From: Paul Mood
Sent: Friday, November 16, 2018 9:04 AM
To: Brian Dalke; Jeremy Knapp
Cc: Dawn Marie Buckland; Paul Michaud; Paul Mood
Subject: Lincoln Drive Median Access
Attachments: Lincoln Median Access - Engineering Dept. Review.pdf; ATT00001.htm; Lincoln Median Access Kimley Horn 3rd Party Review.pdf; ATT00002.htm

RE: Lincoln Drive Median Access from Mockingbird Lane to the Eastern Town Limits

MEMORANDUM

Subject: Lincoln Drive, Mockingbird Lane to Town of Paradise Valley (TOPV) Jurisdiction
Median Breaks and Access
Third Party Traffic Review Comments

Kimley-Horn Comments on
CivTech Access Assessment Option 1 through 3

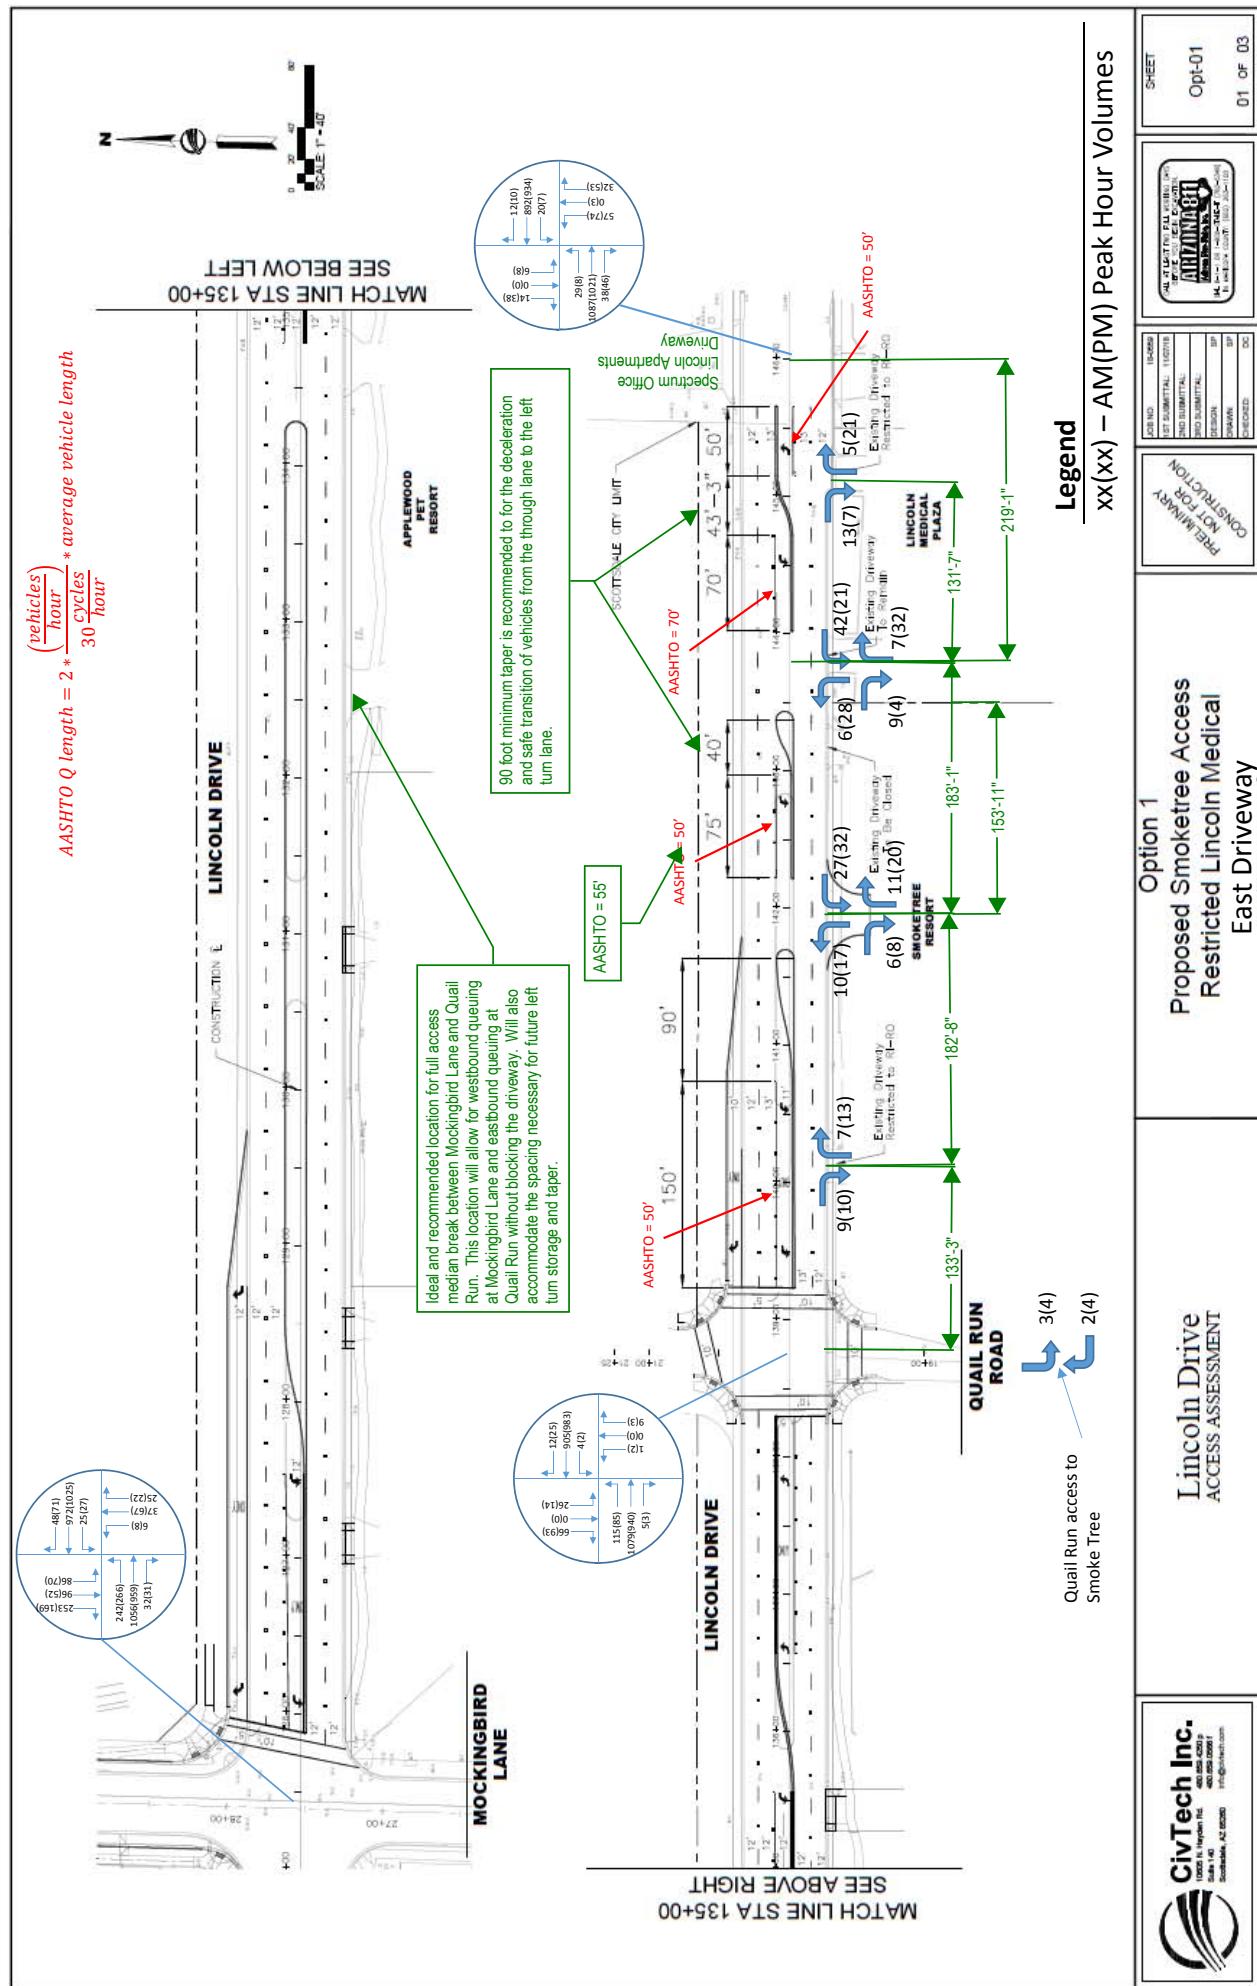
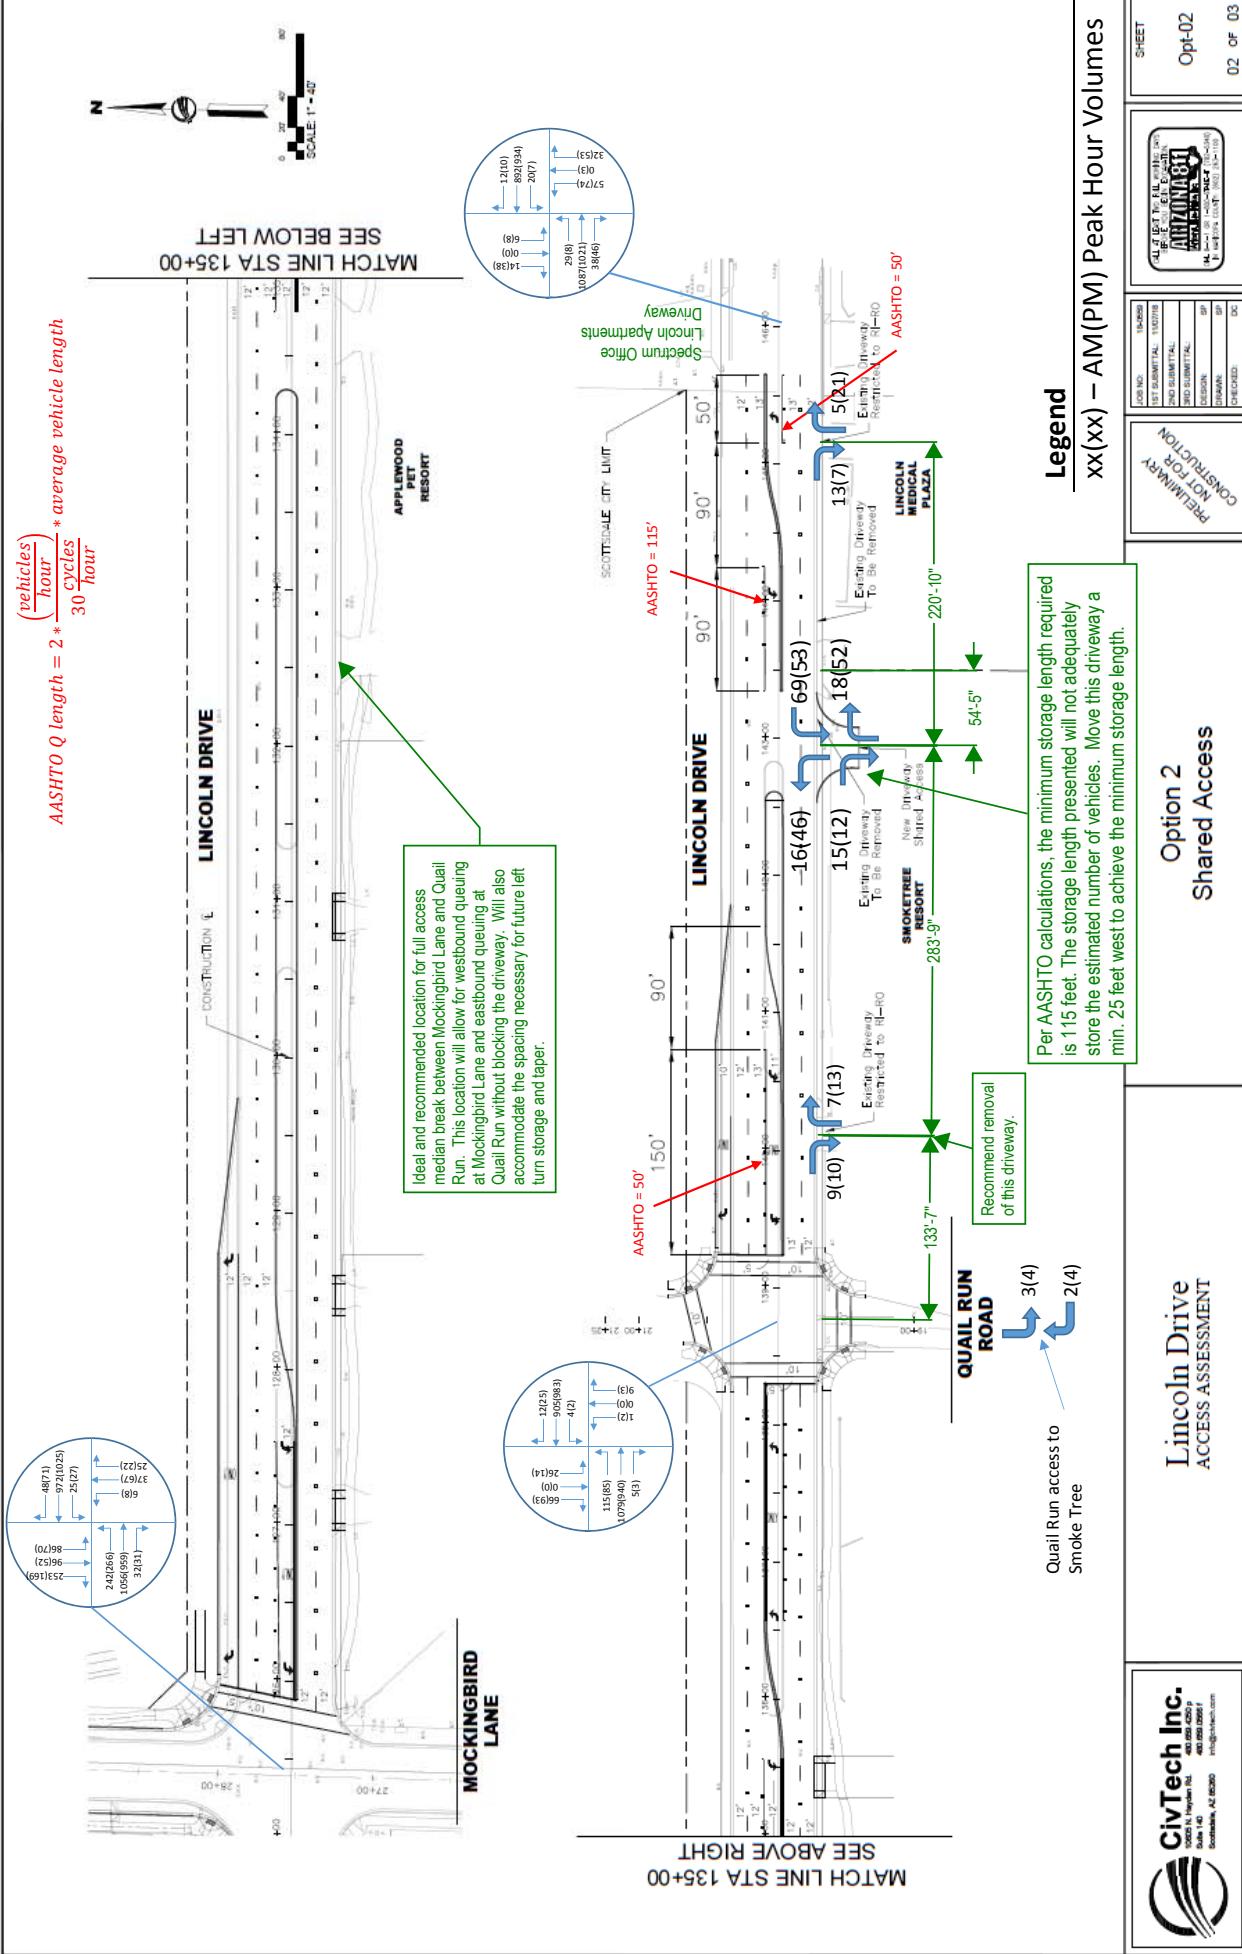
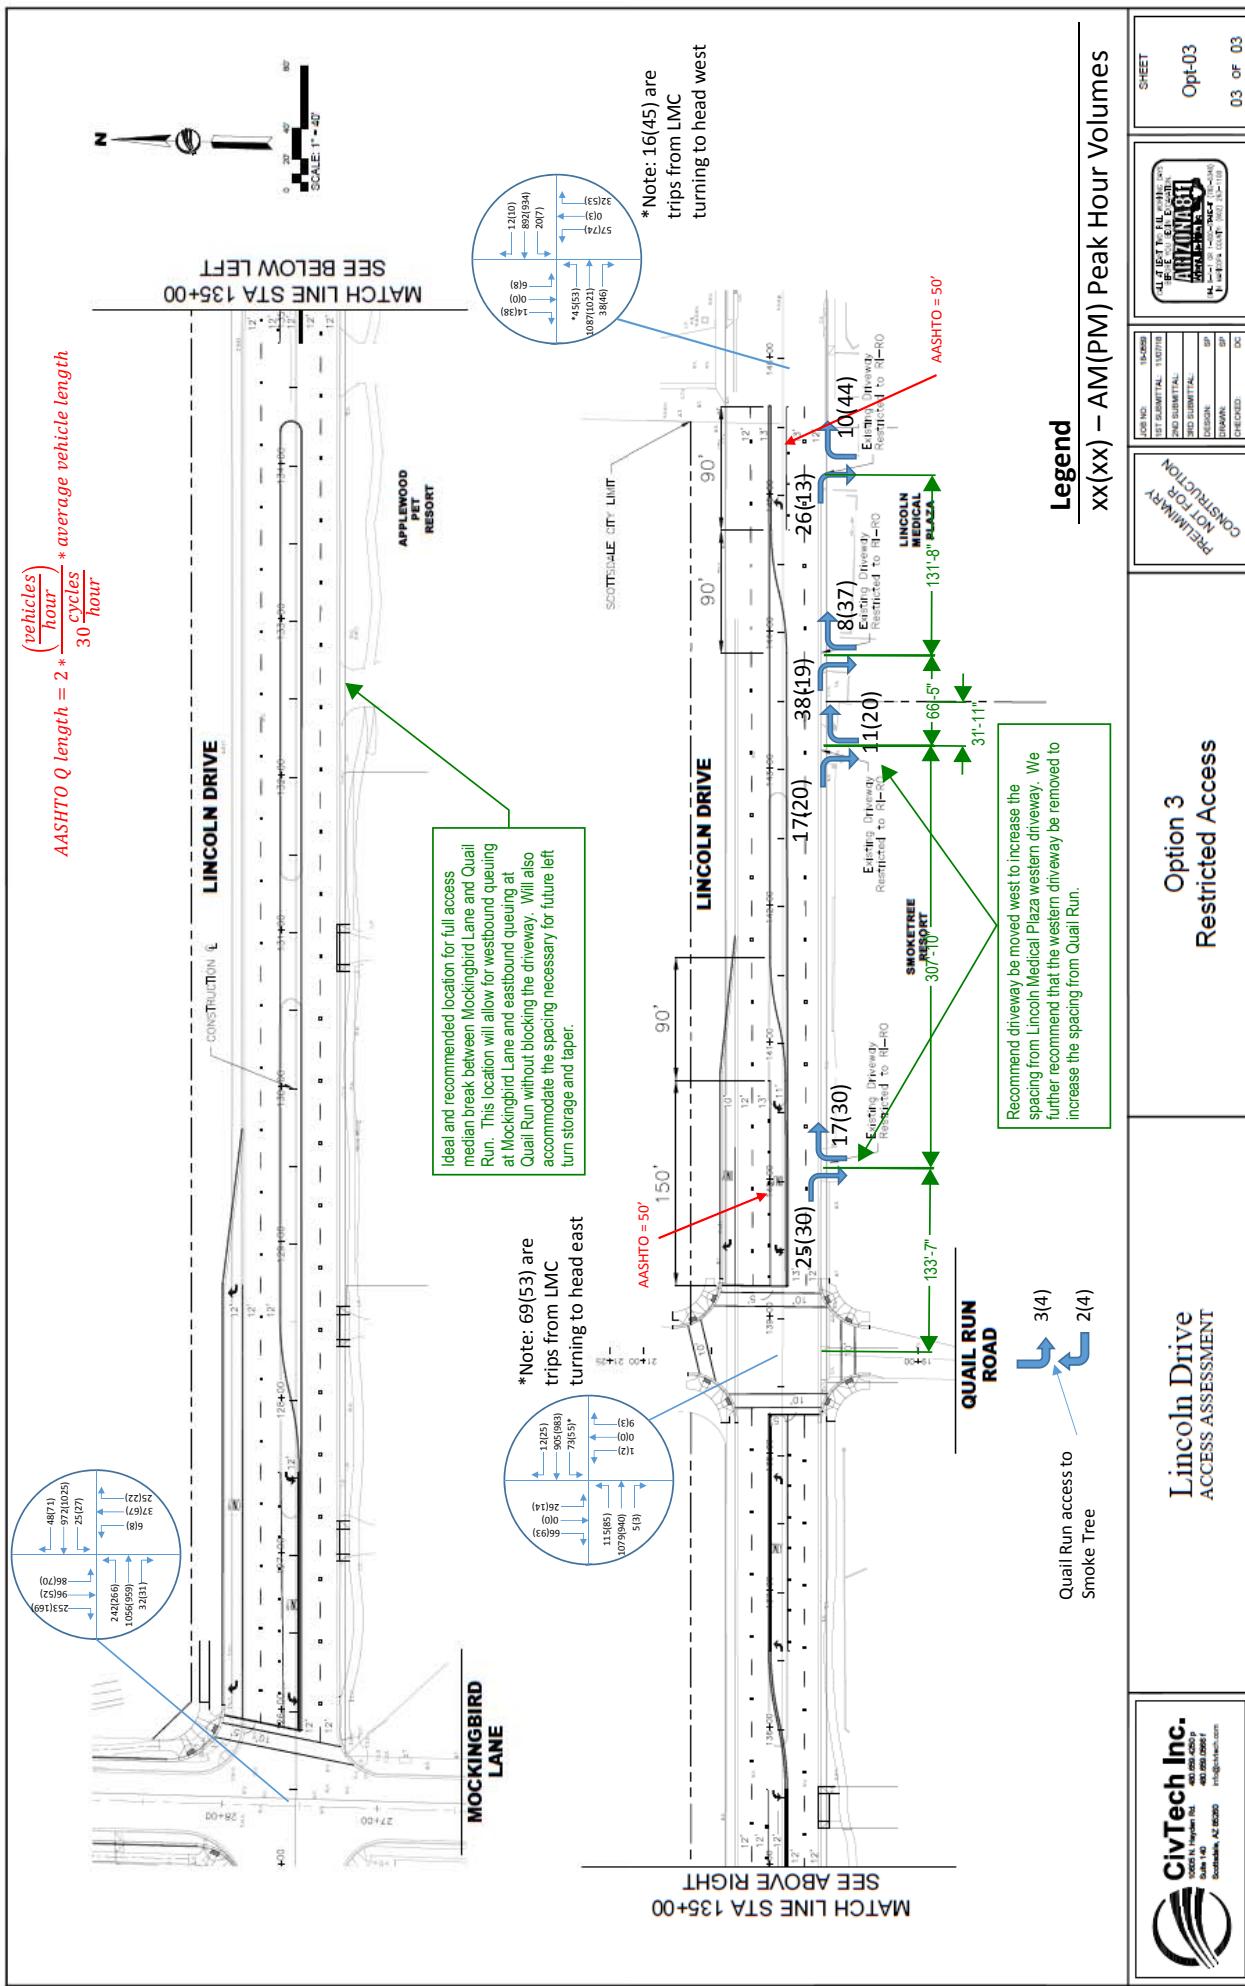
KH Comment 10: Storage length at Spectrum Office Driveway/AJ Driveway calculation ((29 vph x 25 feet x 2)/30) is 48 feet. Per AASHTO, the minimum storage length is 50 feet. Exhibit illustrates a minimum of 50 foot being provided. This is considered acceptable.

KH Comment 11: As shown in Option #1 exhibit, access improvements include closure of the existing eastern access on Smoke Tree Resort, a new Smoke Tree Resort access approximately 183 feet west of Lincoln Medical Plaza access, and the existing Smoke Tree Resort western access to remain as right in/right out. The proposed improvements result in the following spacing (centerline to centerline) of driveways:

Based on the results, Kimley-Horn recommends the western Smoke Tree Resort driveway be closed to achieve the minimum spacing from Quail Run.

KH Comment 12: *The storage length shown in Option #1 exhibit for Lincoln Medical Plaza is 70 feet. Per AASHTO calculations, storage length should be no less than 70 feet to adequately store the estimated number of vehicles generated by Lincoln Medical Plaza. This is considered acceptable. The storage length for the Smoke Tree Resort eastern driveway is 75 feet. Per AASHTO calculations, storage length should be no less than 55 feet to adequately store the estimated number of vehicles generated by the Smoke Tree Resort. This is considered acceptable.*

KH Comment 13: *As shown in Option 1 exhibit prepared by CivTech, opening bay tapers are 40 feet at Smoke Tree Resort and 43-3" feet at Lincoln Medical Plaza. KH recommends that no less than a 90-foot opening taper be utilized to safely traverse traffic from the through lane to the left turn lane on Lincoln Drive, per the criteria and discussion on Page 4, 5, and 6 of this document. Kimley-Horn recommends the median be extended and access points to Lincoln Medical Plaza be restricted to right in/right out only movements for two reasons:*

KH Comment 14: As shown in Option #2 exhibit, access improvements include closure of the western Lincoln Medical Plaza access, a new shared access for the Smoke Tree Resort / Lincoln Medical Plaza approximately 55 feet from the shared Smoke Tree Resort / Lincoln Medical Plaza parcel line, and right in/right out to all other access points between Quail Run and TOPV jurisdictional boundary line. The proposed improvements in this option result in the following spacing (centerline to centerline) of driveways:

Per City of Scottsdale Design Standards & Policy Manual (2018), the minimum driveway spacing is presented the minimum spacing required (250 feet) on Lincoln Drive. Kimley-Horn recommends the western Smoke Tree Resort driveway be closed to achieve the minimum spacing from Quail Run.

KH Comment 15: As shown in Option 2 exhibit prepared by CivTech, opening bay taper to the shared Smoke Tree Resort and Lincoln Medical Plaza is 90 feet. This is considered adequate.

KH Comment 16: The storage length shown in Option #2 exhibit for the shared Smoke Tree Resort/Lincoln Medical Plaza access is proposed at 90 feet. Per AASHTO calculations, storage length should be no less than 115 feet to adequately store the estimated number of vehicles generated by

Smoke Tree Resort and Lincoln Medical Plaza. For this option, the shared access should move a minimum of 25 feet west of the location shown in the CivTech exhibit to accommodate the minimum storage length necessary to adequately store the estimated left turn volumes without spilling back into Lincoln Drive through lanes. This would result in placing the shared driveway a minimum of 80 feet from the Smoke Tree resort/Lincoln Medical Plaza parcel line.

KH Comment 17: *As shown in Option #3 exhibit, all existing driveways between Quail Run and eastern Lincoln Medical Plaza access points, will remain and be restricted to right in/right out only. This results in the following spacing (centerline to centerline) between the existing driveways:*

Per City of Scottsdale Design Standards & Policy Manual (2018), the minimum driveway spacing is presented the minimum spacing required (250 feet) on Lincoln Drive. Kimley-Horn recommends the western Smoke Tree Resort driveway be closed to achieve the minimum spacing from Quail Run. We further recommend that with the improvements to both Smoke Tree Resort and Lincoln Medical Plaza that the driveways be improved to achieve the minimum spacing.

KH Comment 18: *This option does provide the safest option by removing the conflict points that would occur with left in/left out maneuvers. It should be noted that Lincoln Drive does not provide enough pavement width necessary to safely make U-turn maneuvers. Providing an access point that is located to safely transition and adequately store the estimated left turn volumes will reduce the need for U-turn maneuvers. Allowing shared access between the Smoke Tree Resort and Lincoln Medical Plaza parcels would remove the need for any U-turn maneuvers. For this option, should it be determined that shared access will not be provided, Kimley-Horn recommends U-turns be restricted.*
